Our Ref: 16015 – RFS Response – Huntlee Stage 2 - 20251024
Via: email

RE: DEVELOPMENT APPLICATION S100B – HUNTLEE NEW TOWN SUBDIVISION – SSD-70748466

MJD Environmental have undertaken a review of the approval issued by the NSW RFS (Ref: DA20250726002963-Response to Submissions-1).

Attachment 1 – APZ and BAL over detailed subdivision layout with Lot numbers

Surveyor: Andrew David McNamara
of DALY.SMITH Pty.Ltd.
Date of Survey:
Surveyors Ref: 20406 STG 2 DA

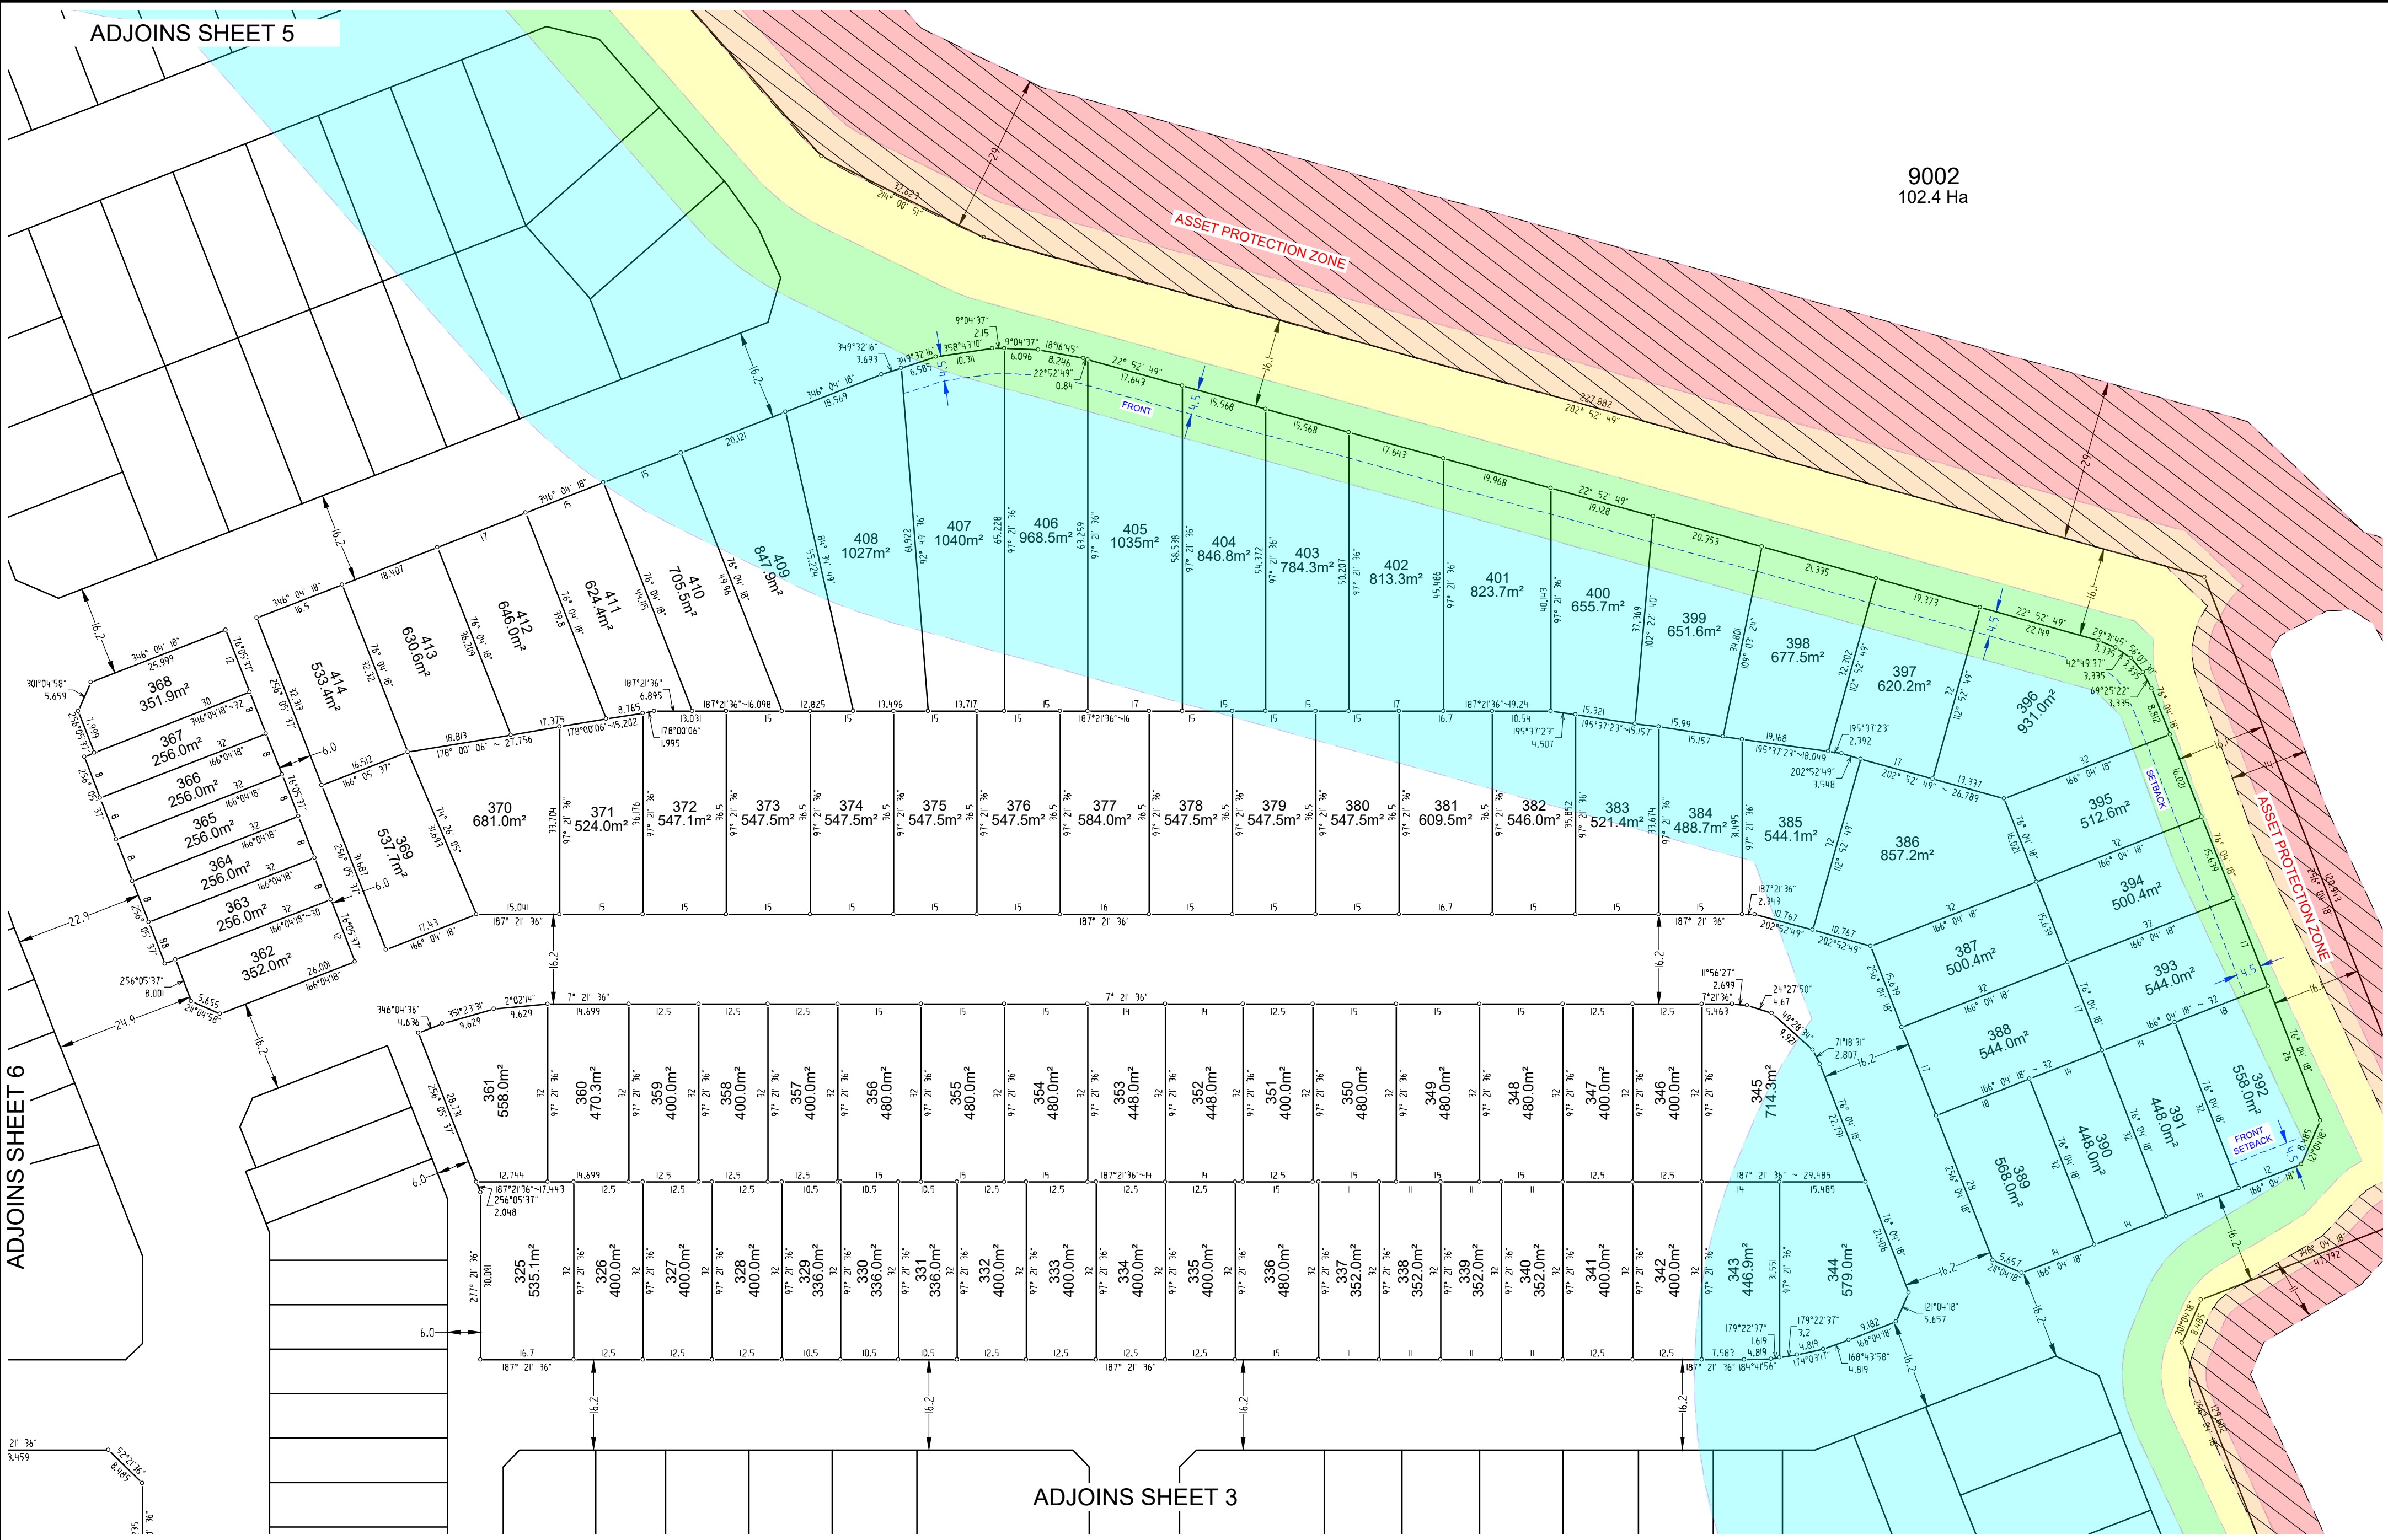
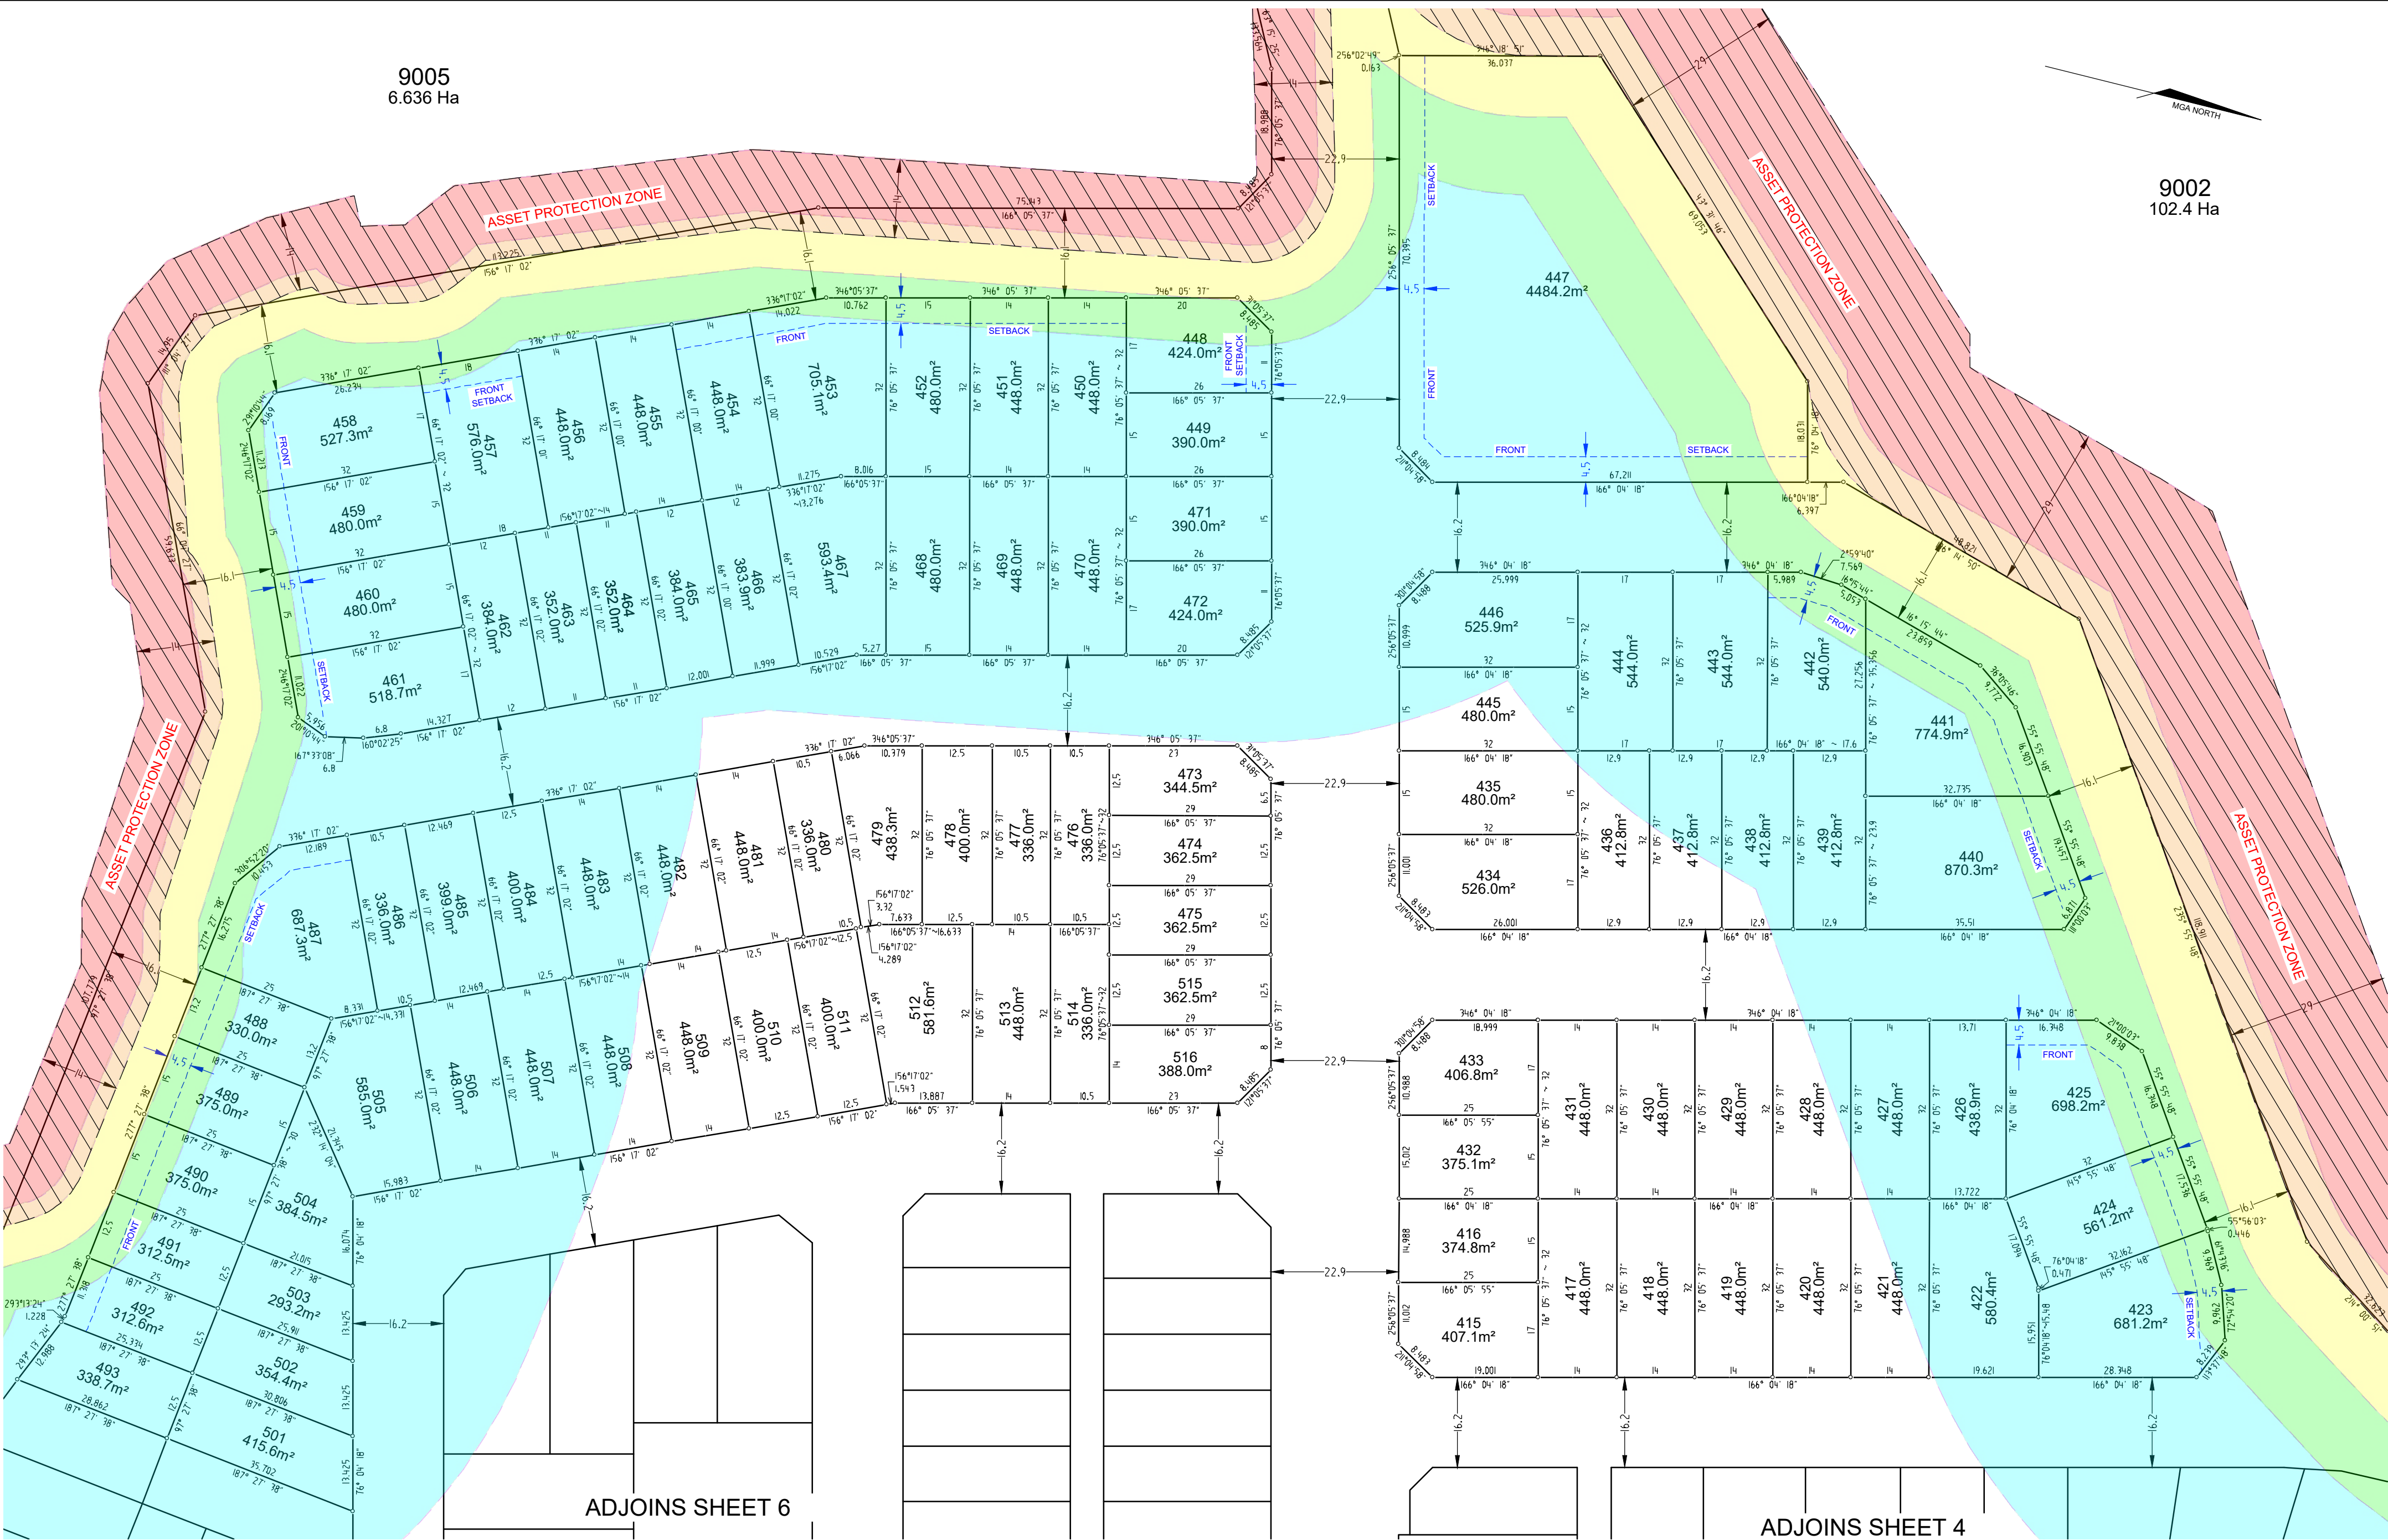
In response to the RFS commentary and request provided under approval Condition 3 and acknowledging aforementioned commentary contained under Condition 1 and Condition 2, please refer to **Attachment 1** that contains APZ and BAL per Figures 20 to 25 over the detailed subdivision layout with Lot numbers. A schedule of Lot numbers and applicable BAL ratings has been provided in **Attachment 2**, covering only those lots affected by BAL.

We request upon review the RFS approve and endorse the BAL plan to provide certainty of applicable BAL for each Lot.
